**REGULAR MEETING OF THE
CITY OF ALVARADO PLANNING AND ZONING COMMISSION
104 W. COLLEGE AVE.
MAY 16, 2024
6:30 PM
AGENDA**

This letter is to inform you that the attached Lone Oak Addition Phase 1 final plat application provided on April 22, 2024 has generated the recommendation of disapproval from the Alvarado Planning and Zoning Commission due to the following comments not being adequately addressed to result in compliance with the Alvarado subdivision ordinance.

ENGINEERING PLANS
FOR
LONE OAK PHASE 1
CITY OF ALVARADO
JOHNSON COUNTY, TEXAS
MARCH 2024

City Engineer Remarks on Preliminary Plat and Preliminary Engineering

STM OS-03

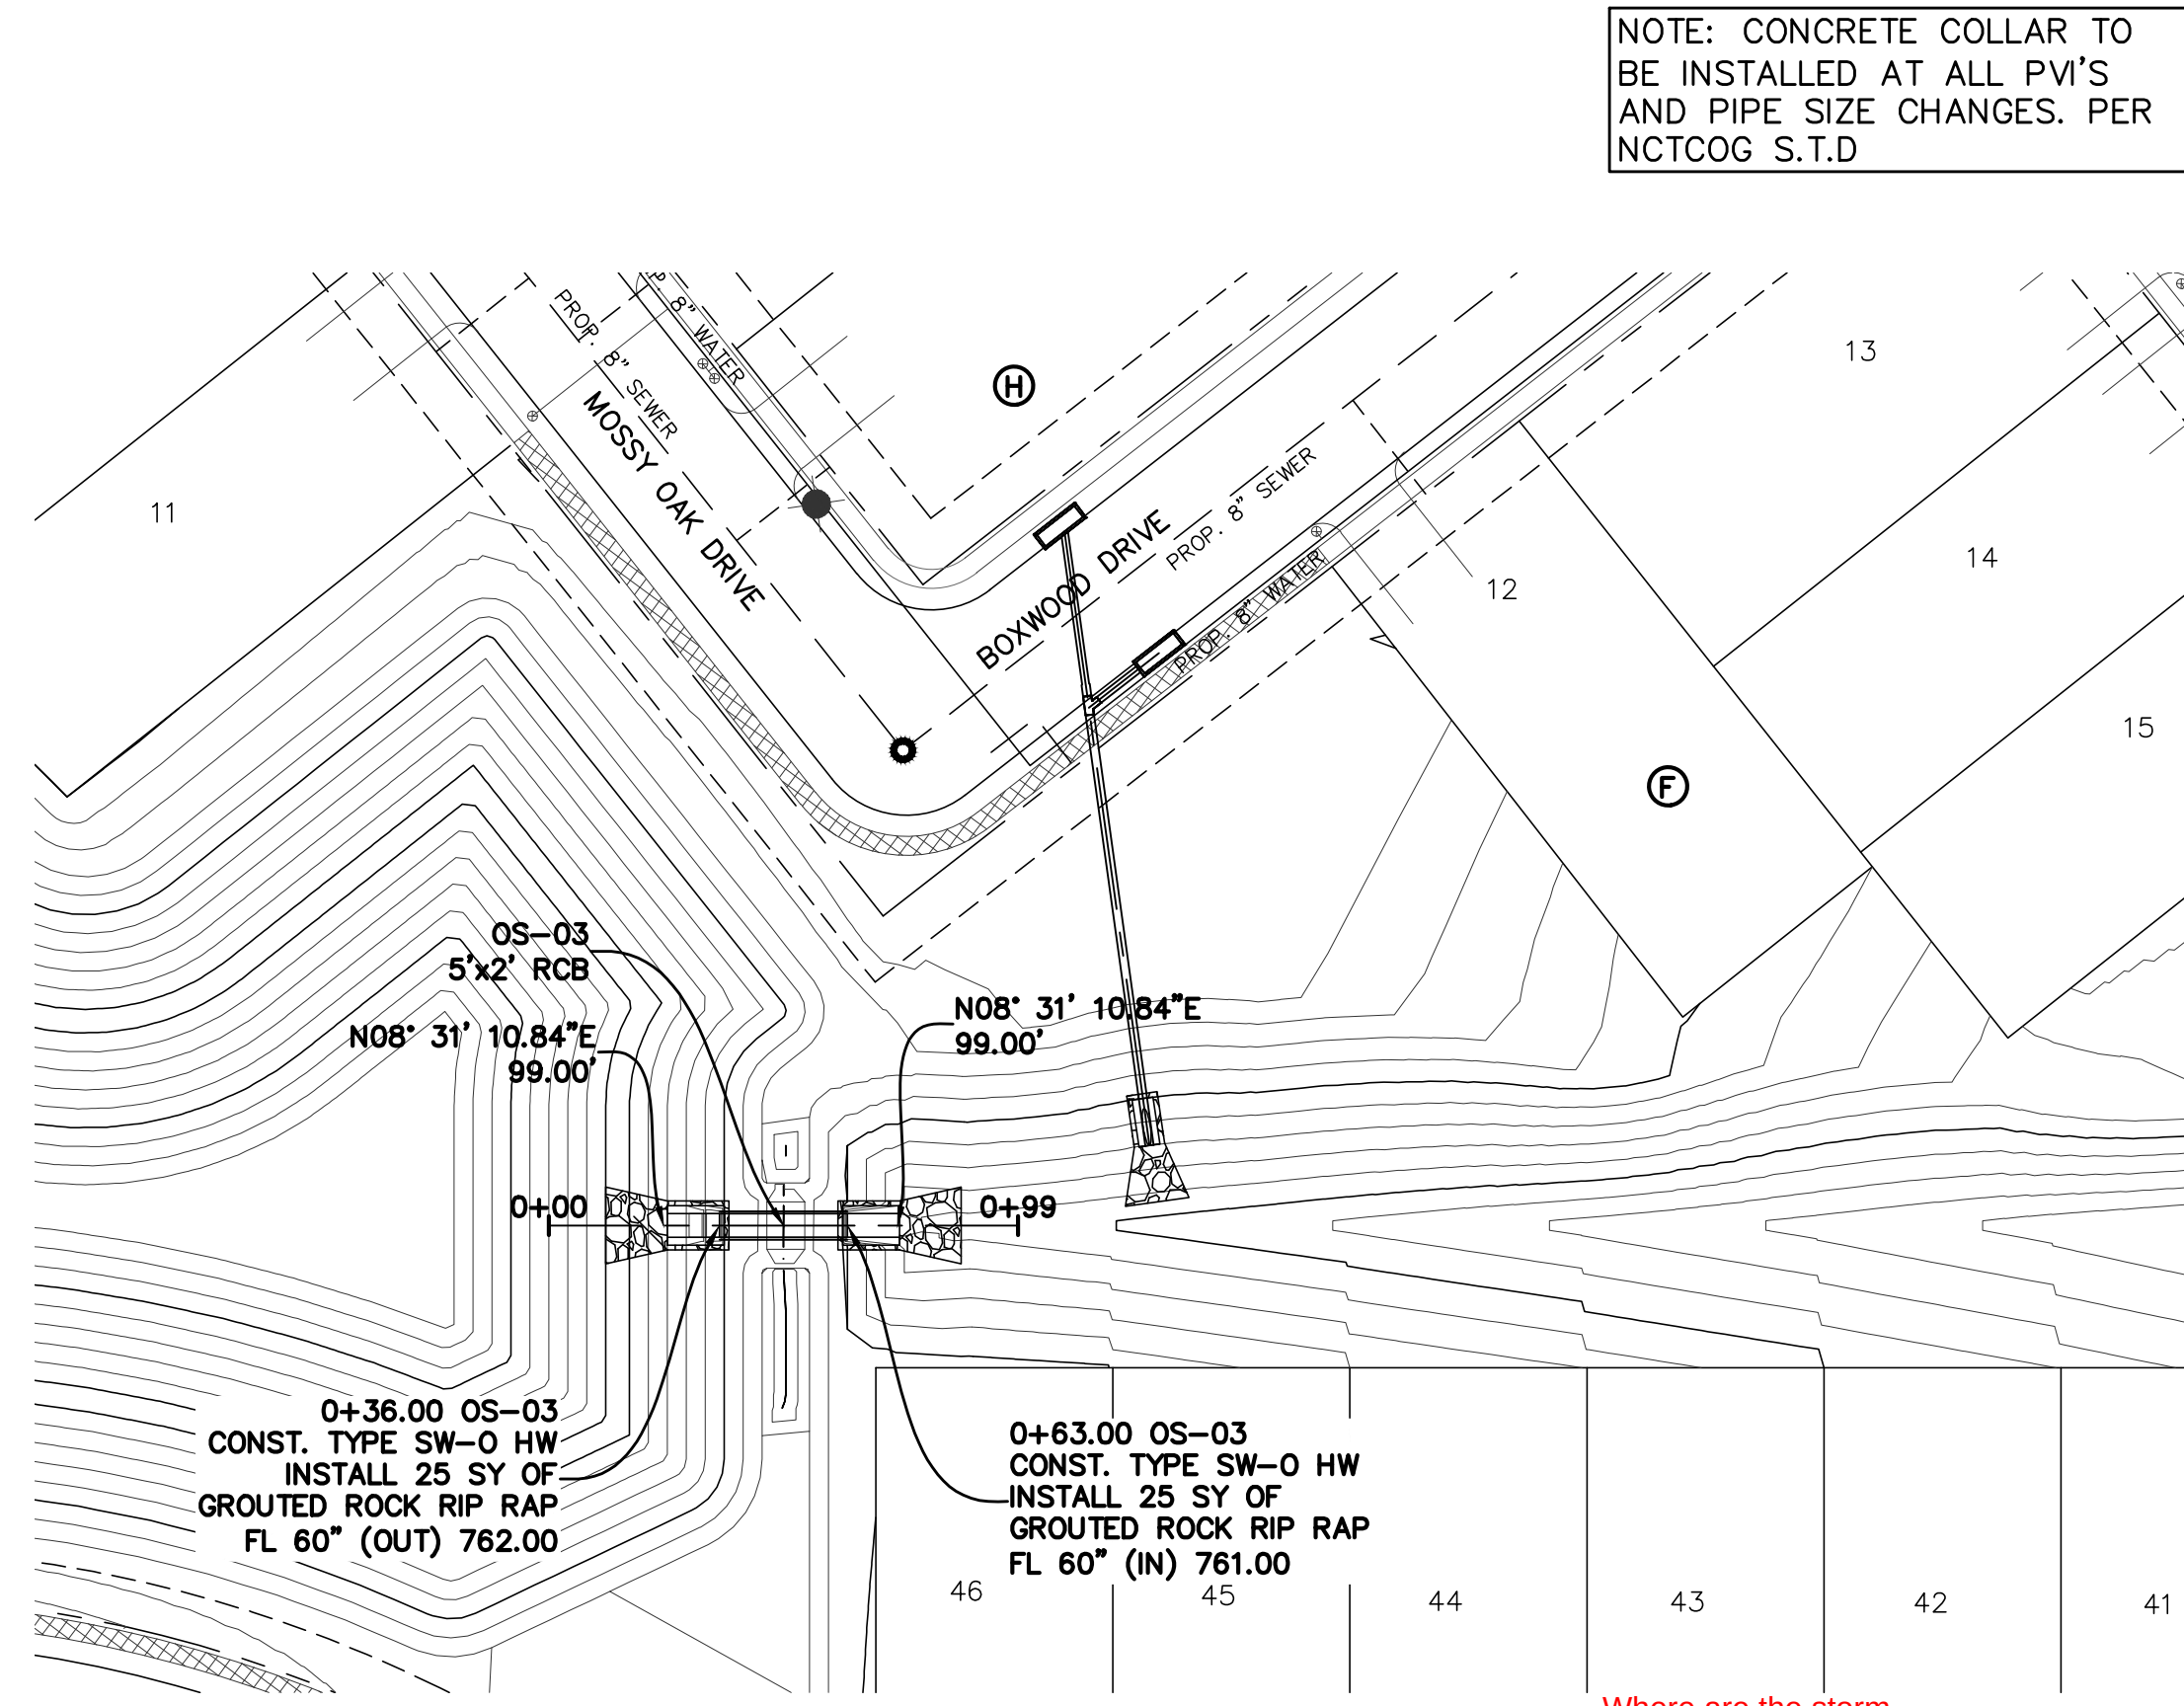
Where are the storm calculations for the box culverts?

LINE C3		PROJECT NO.
STORM SEWER PLAN & PROFILE		BBC010
LONE OAK, PHASE 1		SHEET NO.
City of Alvarado, Johnson County, Texas		5.12

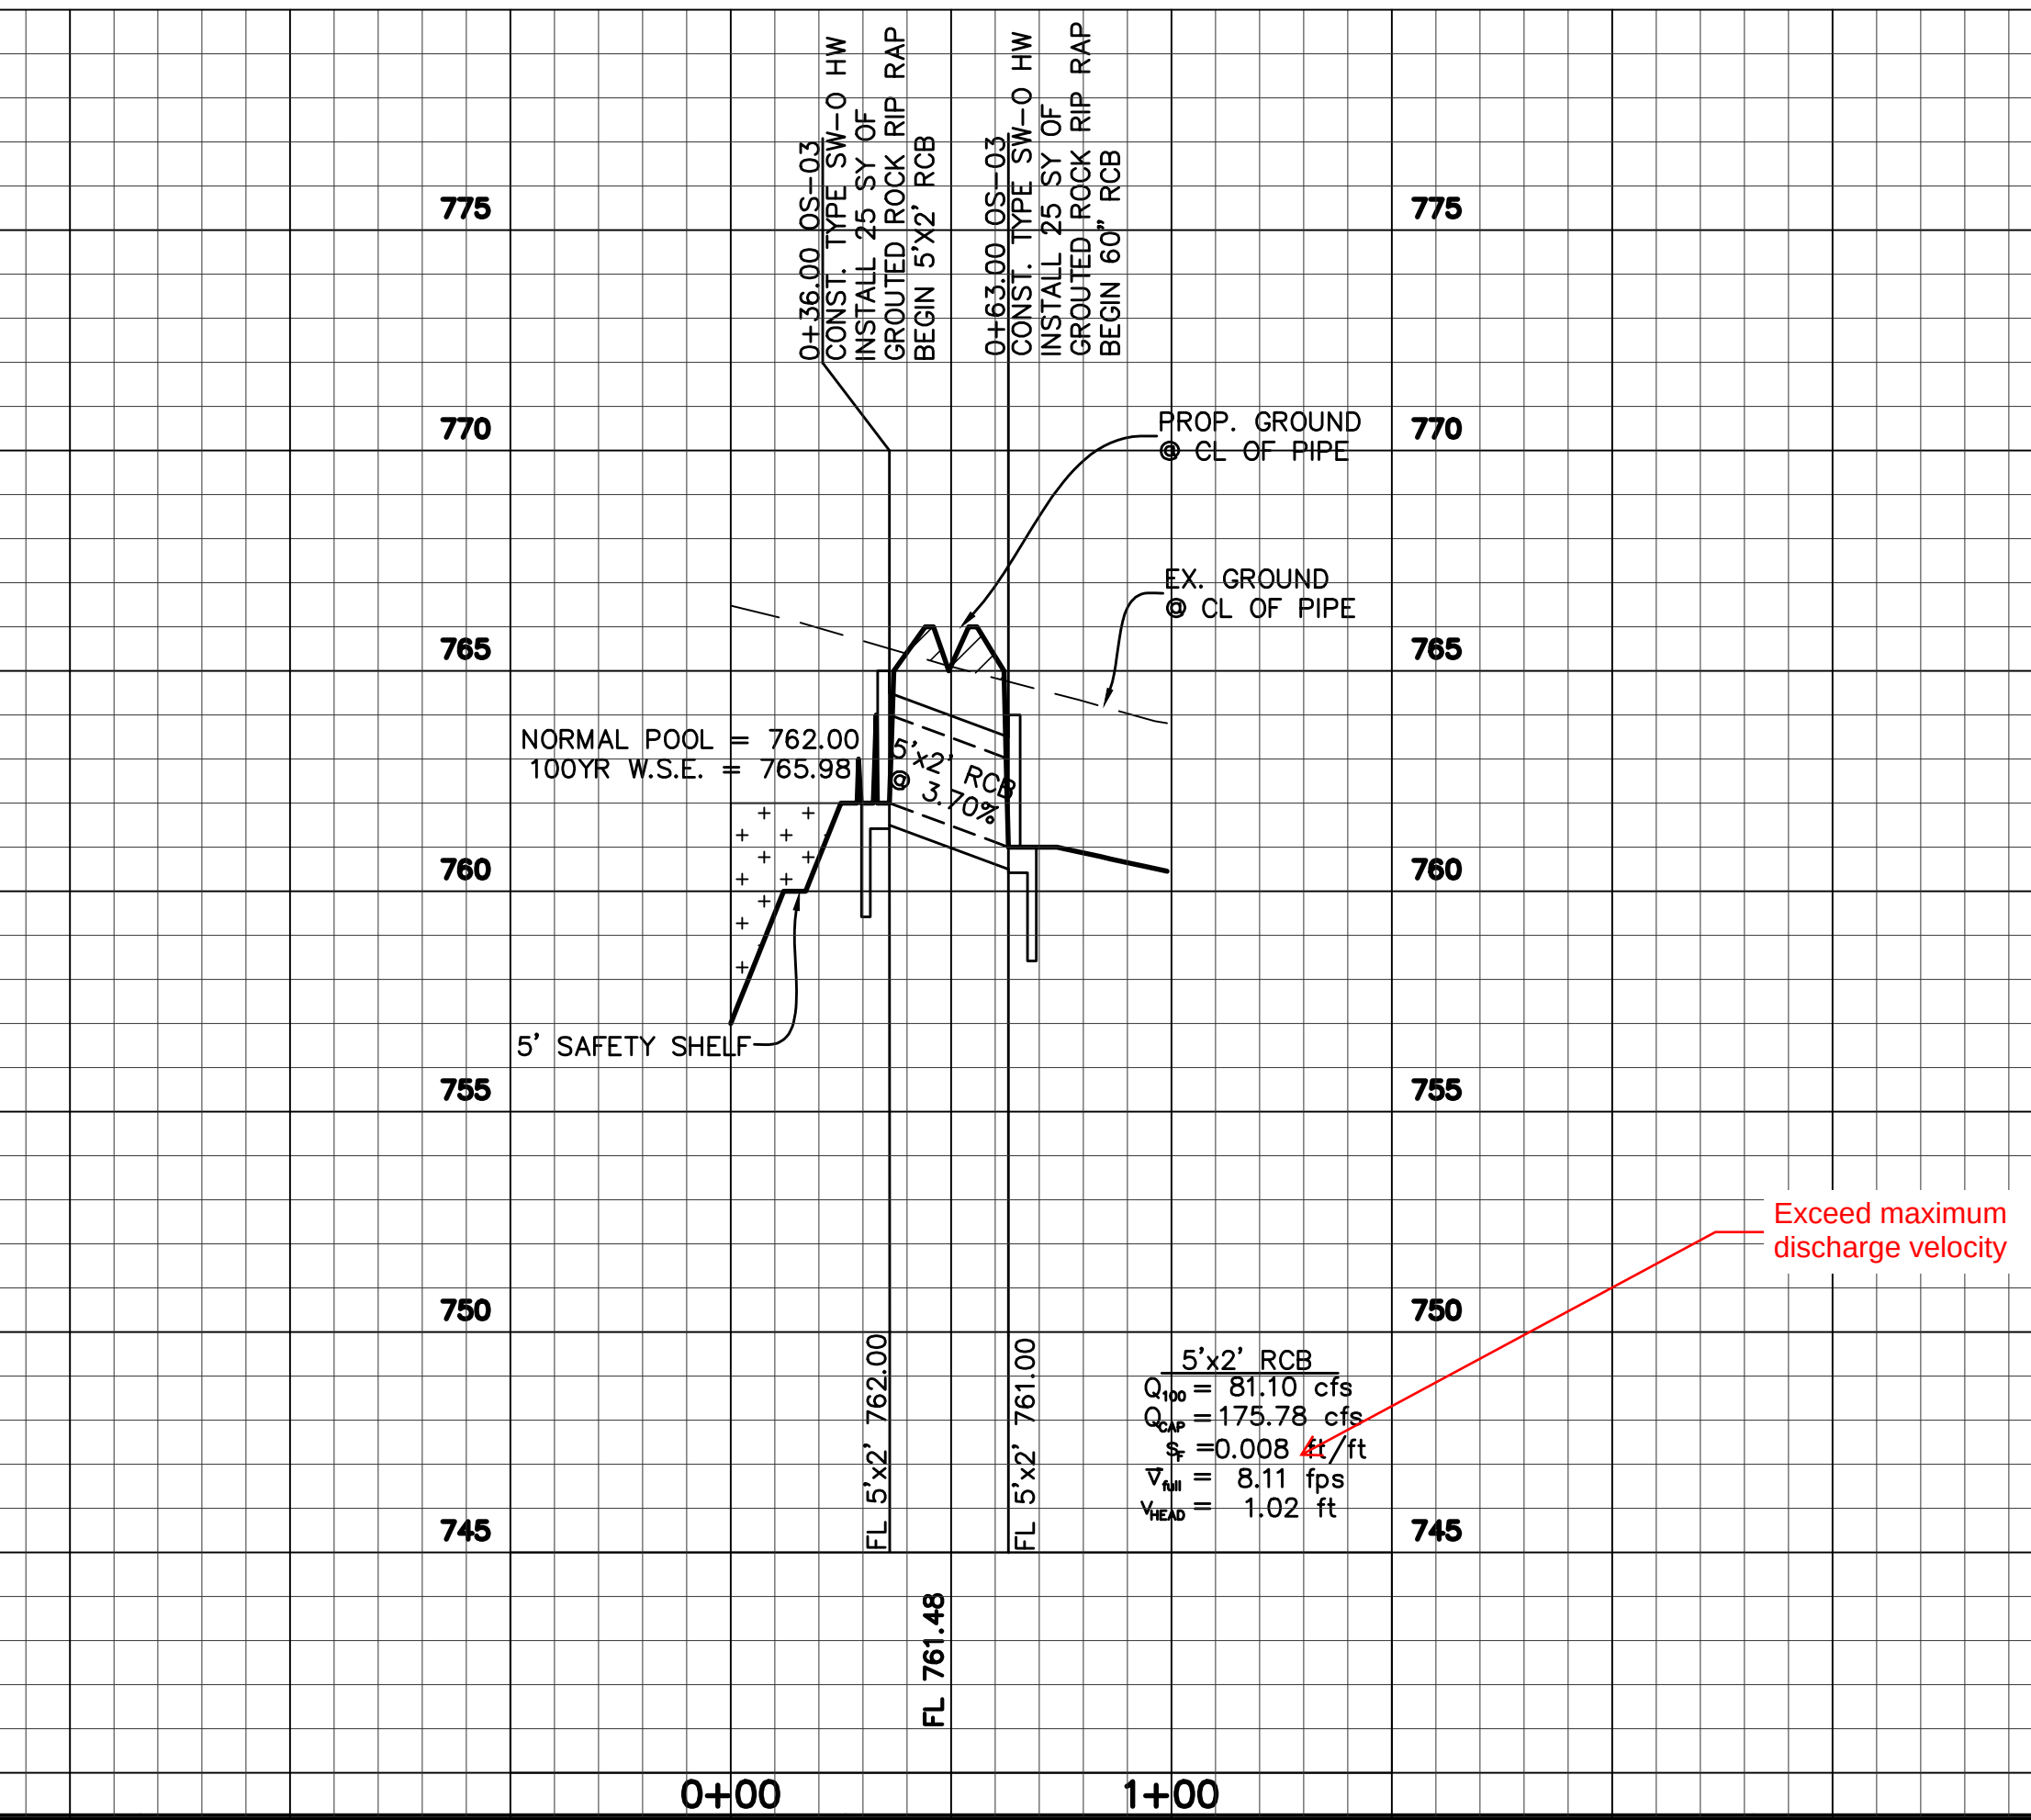
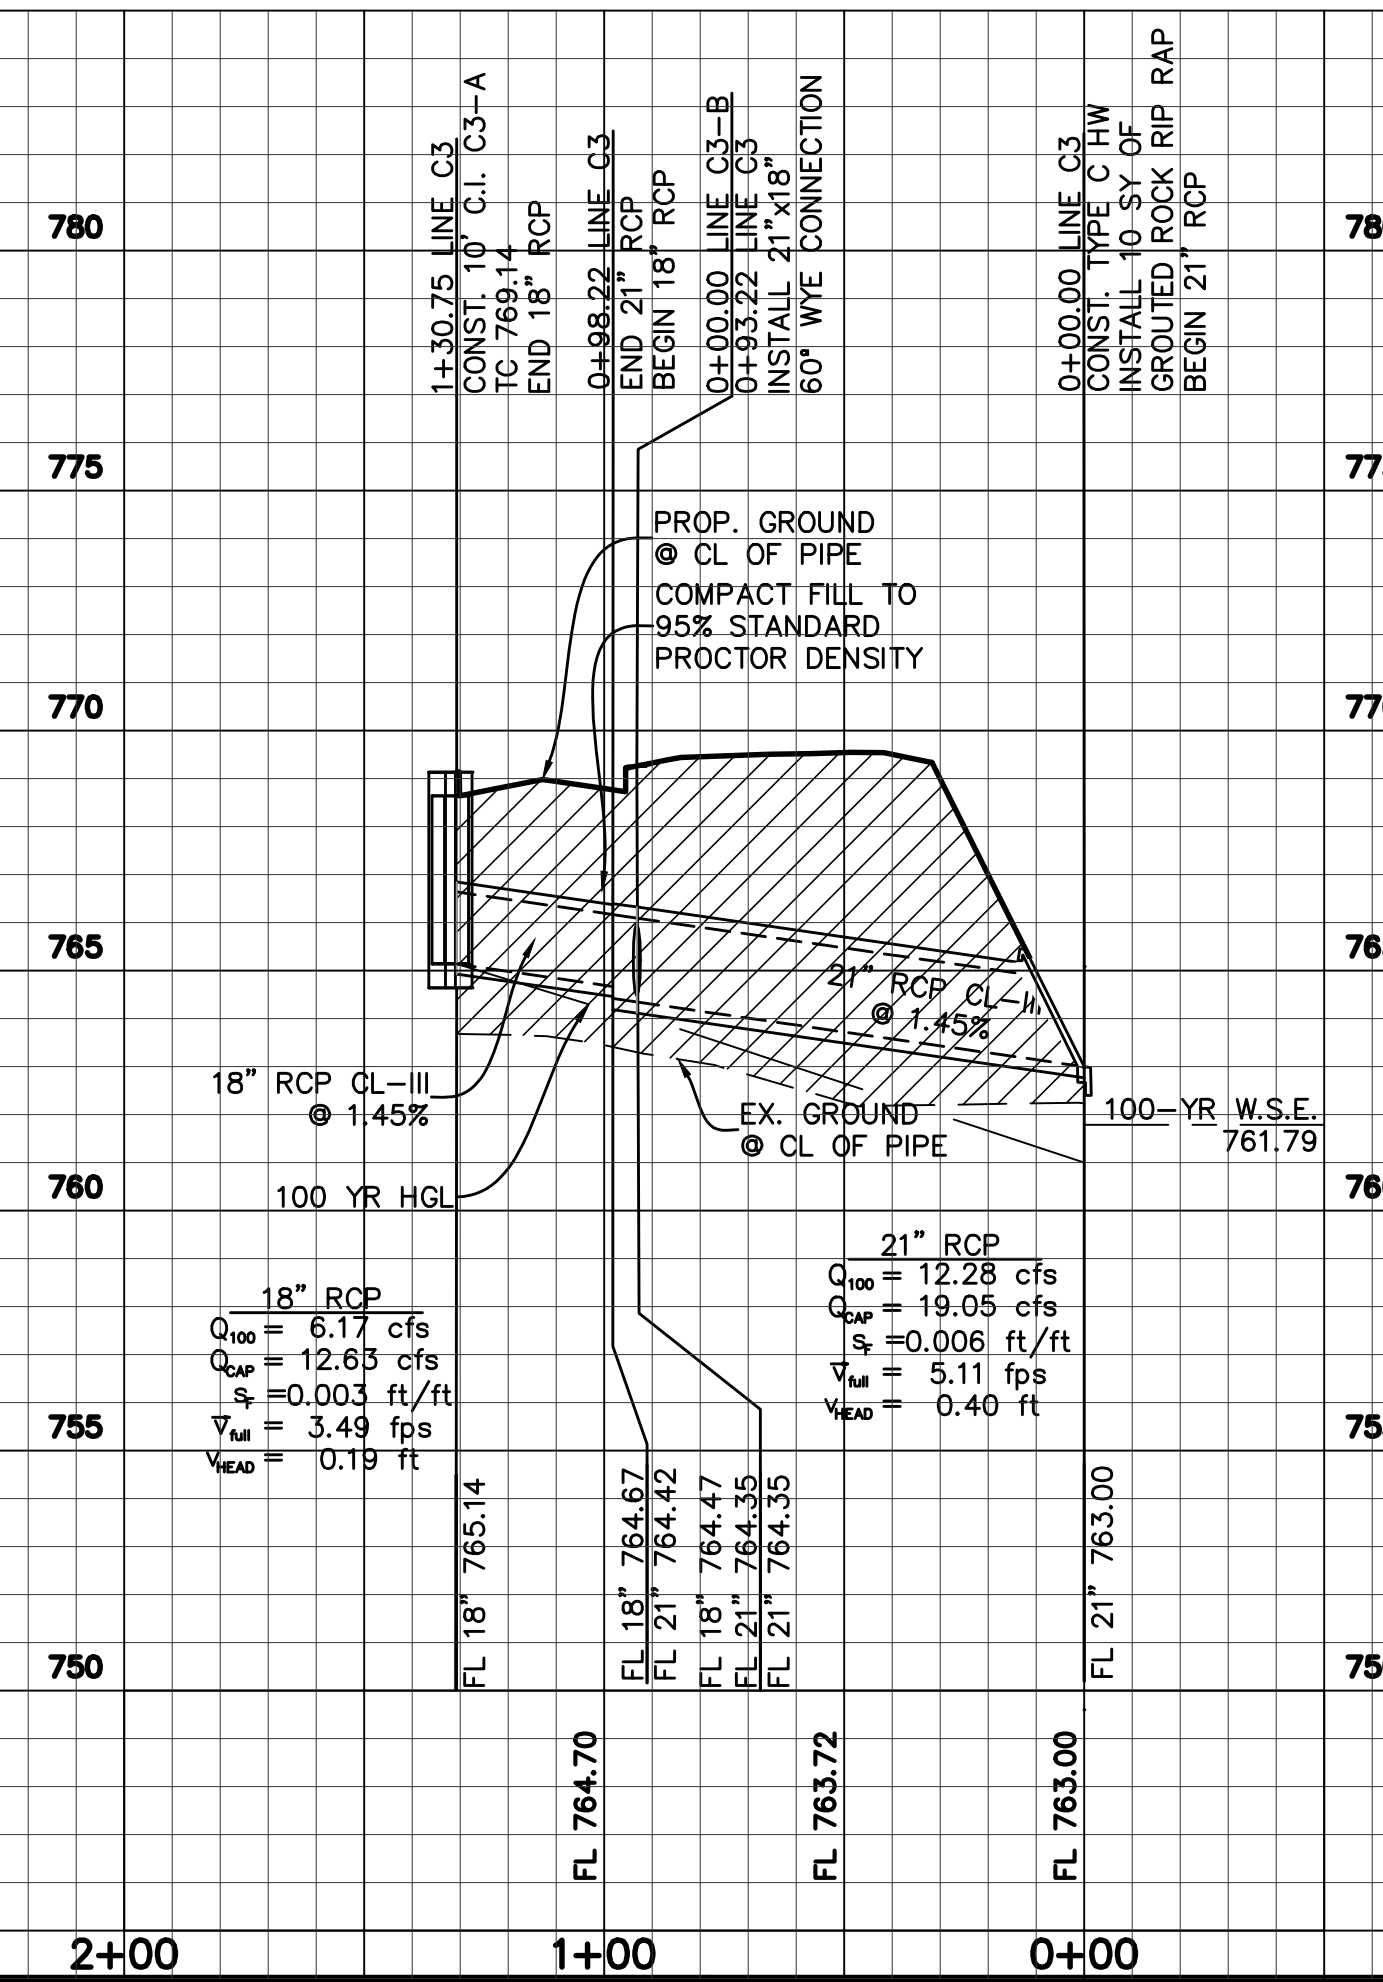
Exceed maximum discharge velocity
